PROPOSED TECHNICAL SPECIFICATION REVISIONS
FOR
REACTOR OPERATION WITH TWO
REACTOR COOLANT PUMPS

Re: Oconee Nuclear Station
Docket Nos. 50-269, -270, -287

RESPONSE TO MR. R. A. PURPLE'S LETTER

RESPONSE TO MR. R. A. PURPLE'S LETTER

FIG 4. (REVISED) FLOODING RATES - LOGA LIMITS - OCCURRING AT
ELEVATION 114 - 16.0 KW/FT AT 2 FT ELEVATION

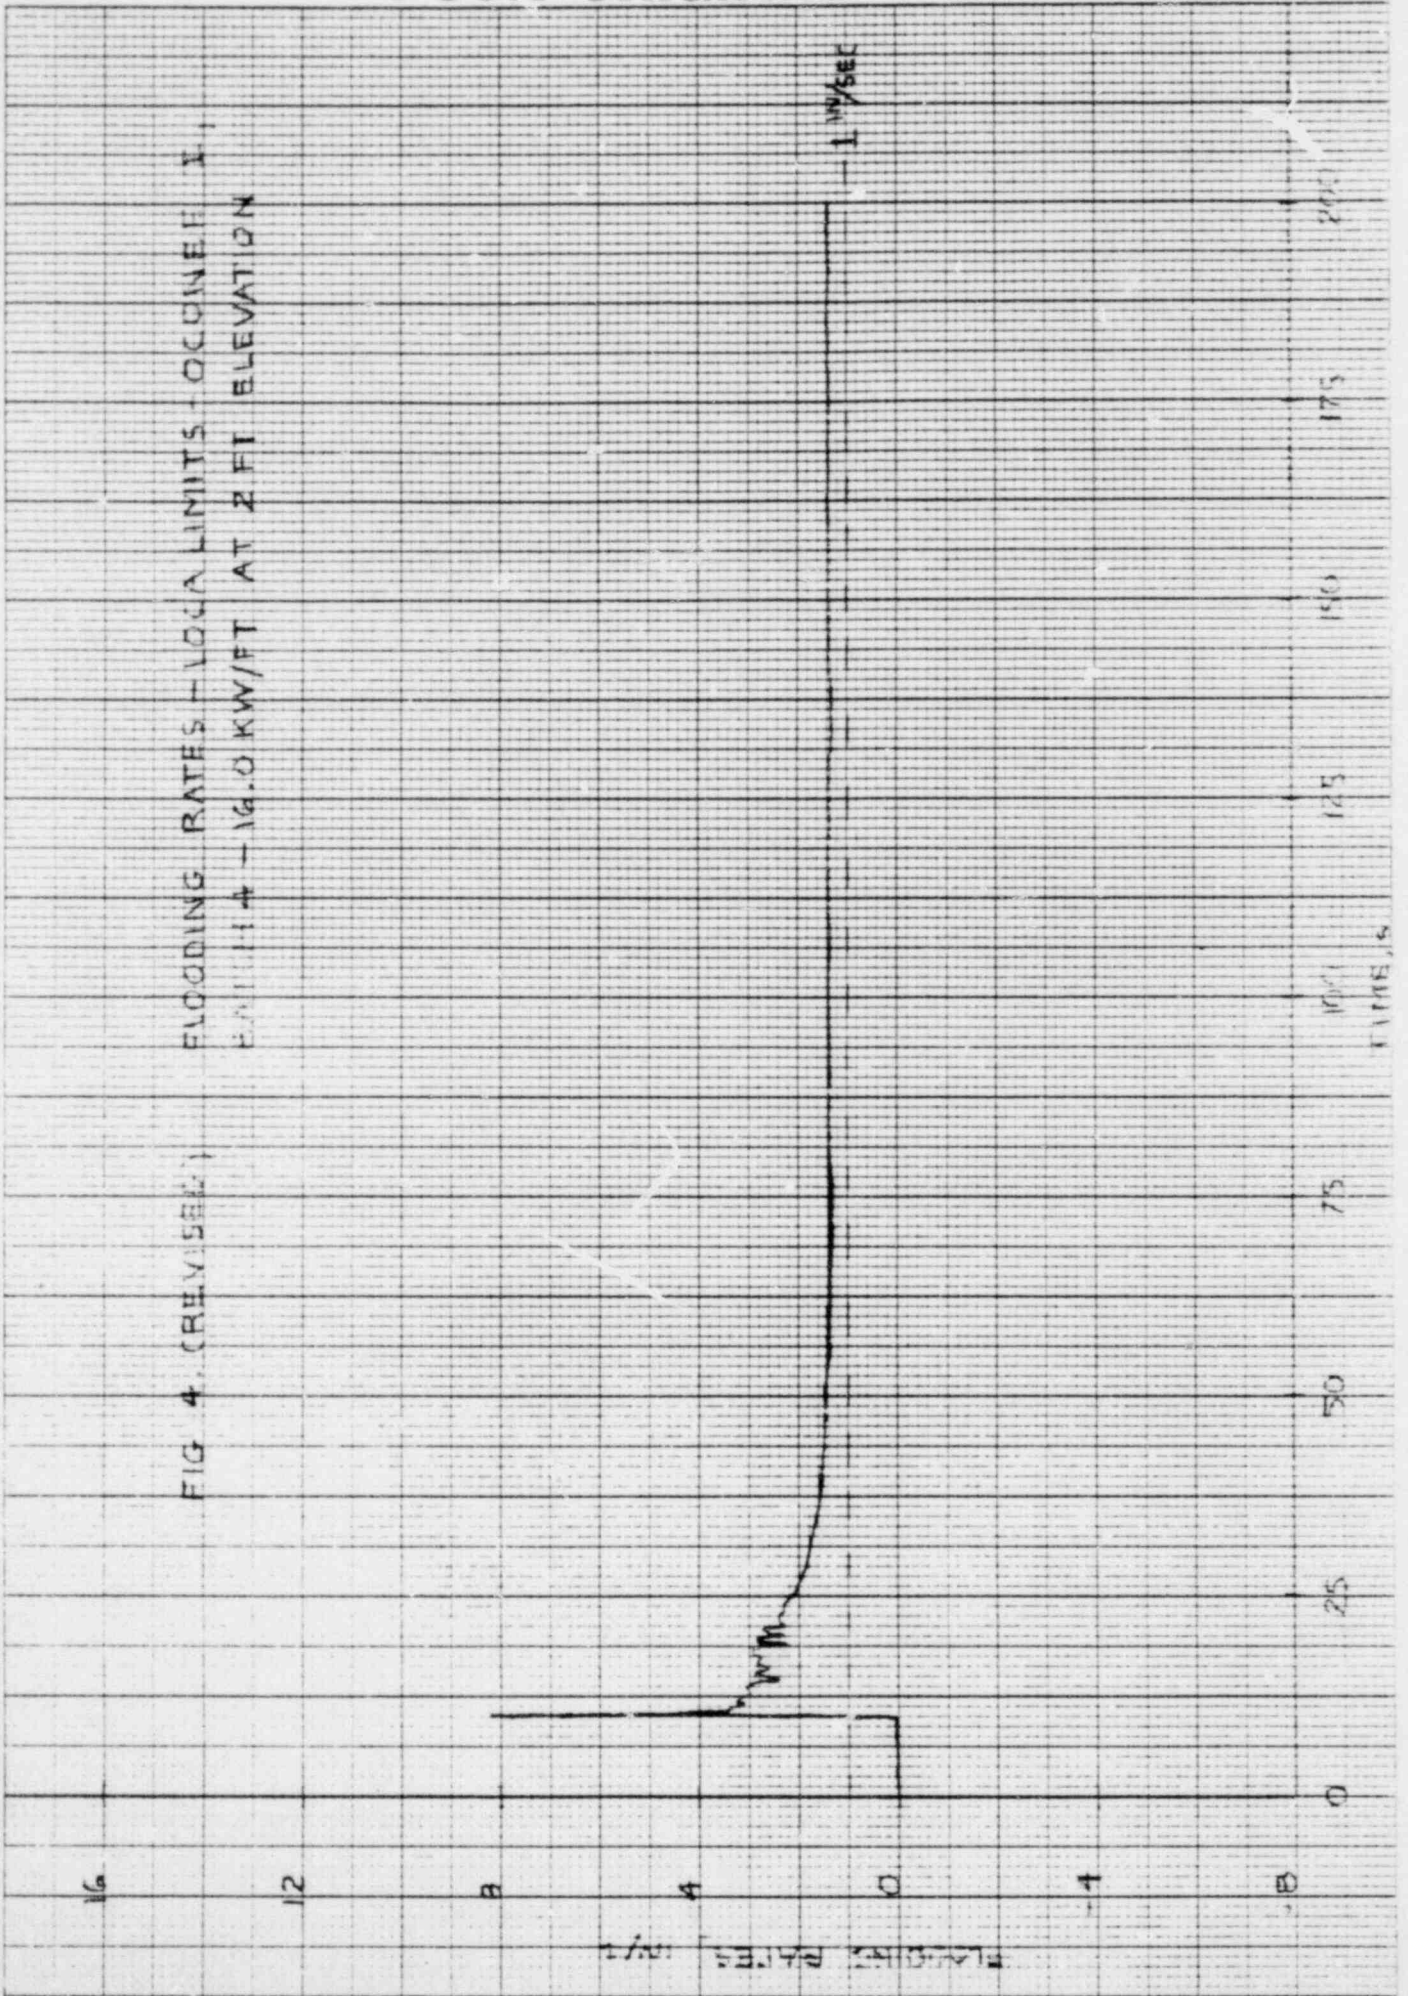
Figures 4 and 8: It is not obvious from these plots that flooding rates of less than 1 in/sec are not predicted. As indicated in the staff's "Minimum Requirements for ECCS Break Spectrum Submittals" dated April 25, 1974, resubmit these figures utilizing engineering graph paper to such a scale as to allow greater reading accuracy.

Figures 4 and 8 have been redrawn on engineering graph paper and are attached.

FIG. B (REVISED) FLOODING RATES - LOCA LIMITS - OCONEE T, BATCH 4 -
17.5 KW/FT AT 4 FT ELEVATION

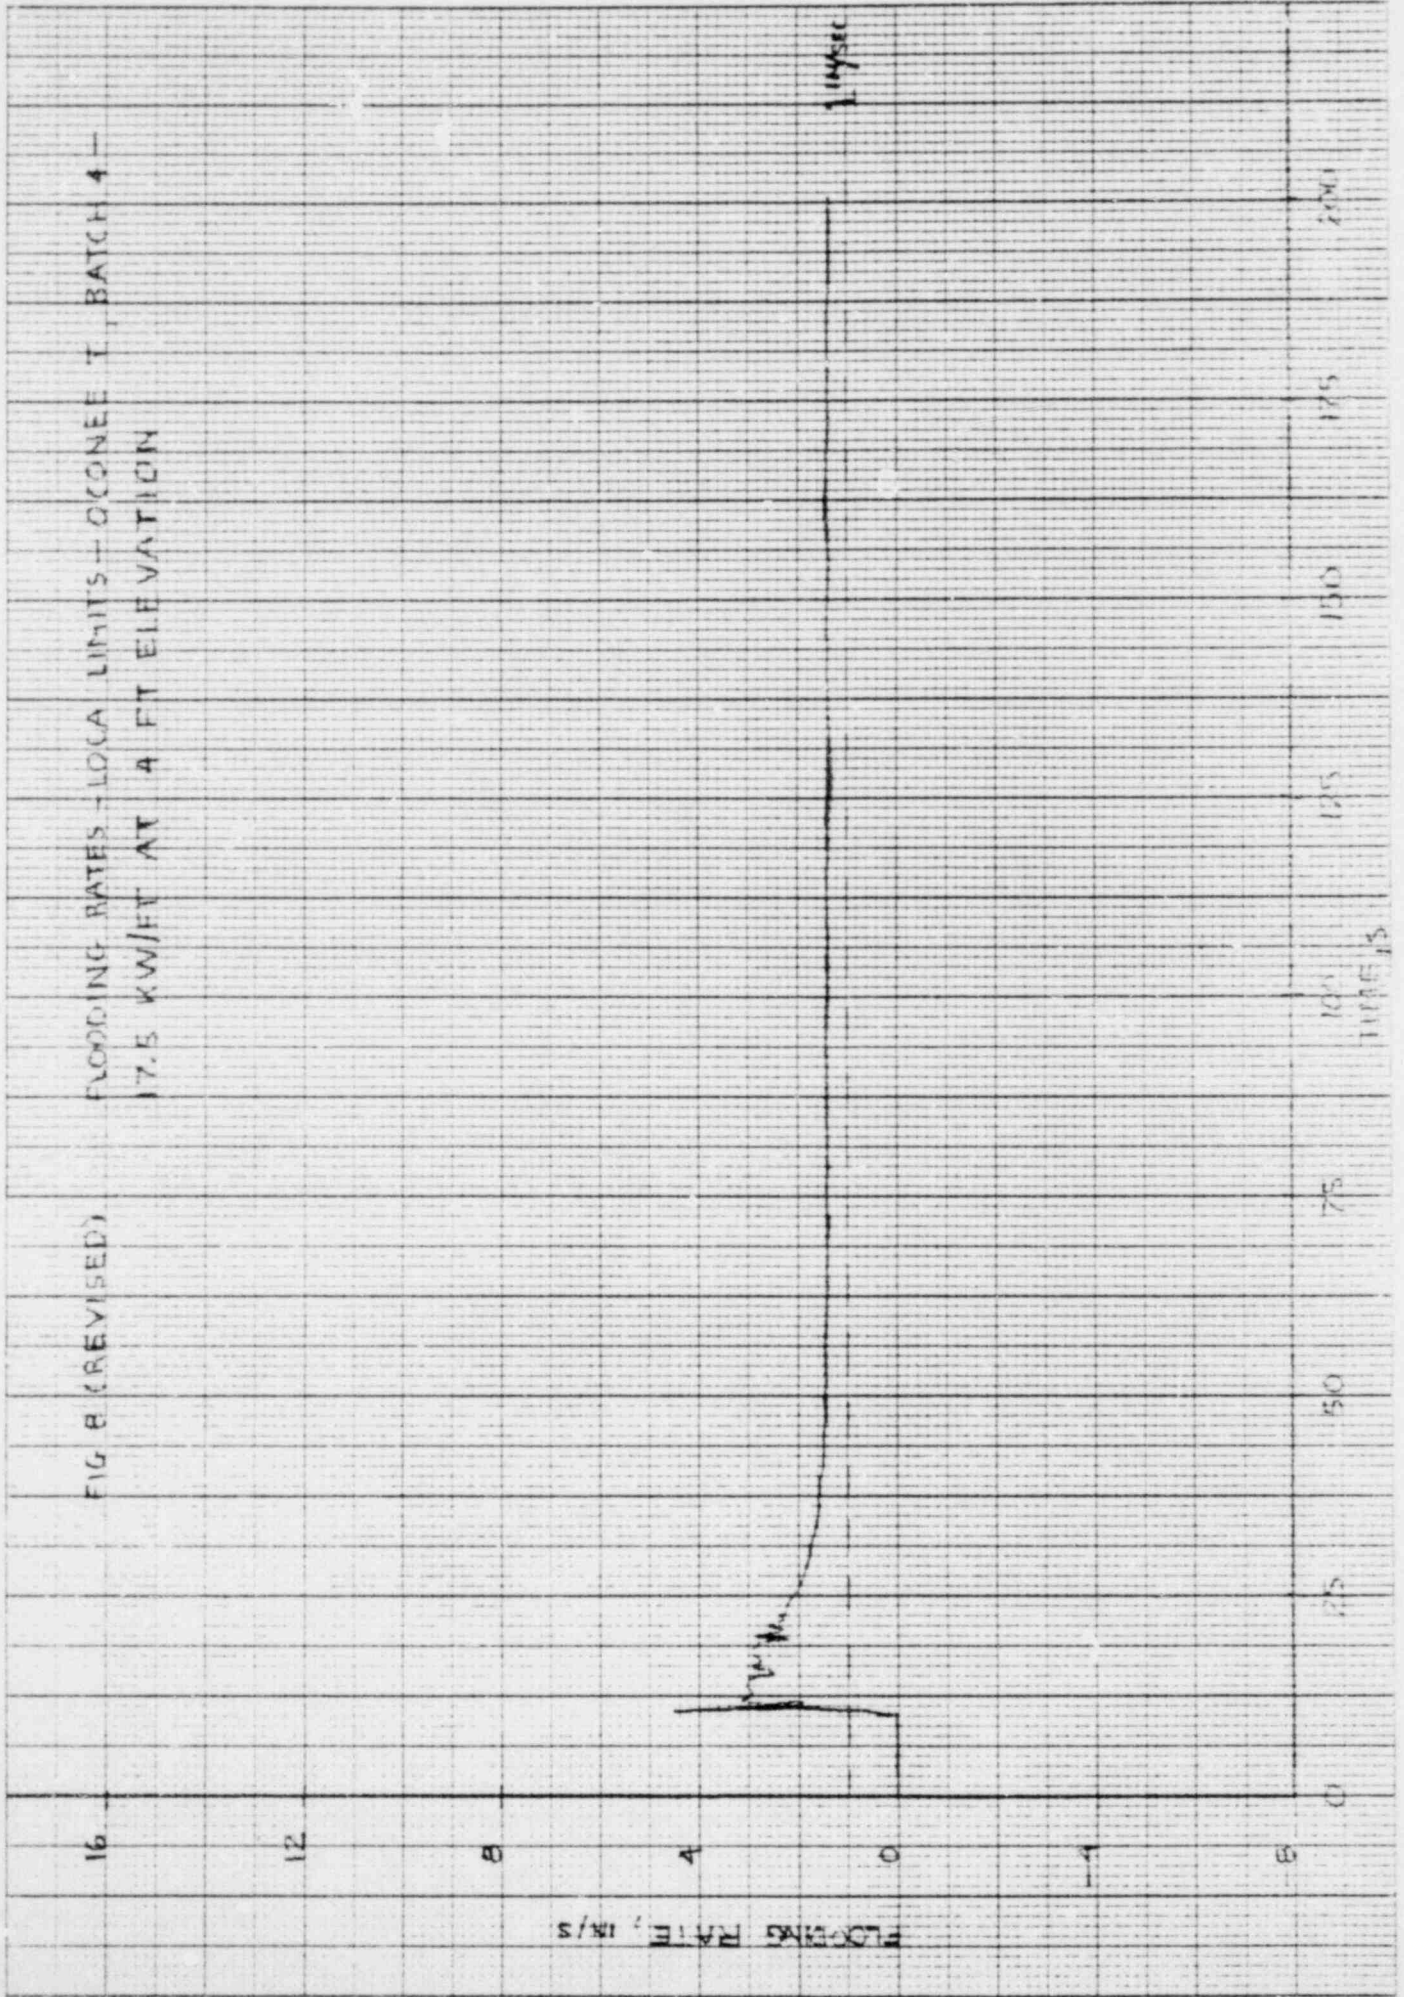
Page 9 indicated that the REFLOOD code version names are different on Figures 4 and 8. If the codes are not the same, describe the differences.

The version name associated with Figure 8, run number RF143(SY) is incorrect. Both that run and run number RF141(IV) were run on the same version of REFLOOD, i.e., REFLOOD 2 Version 2-no loop-dated 12/20/74. This has been verified by checking the actual printout of both runs.
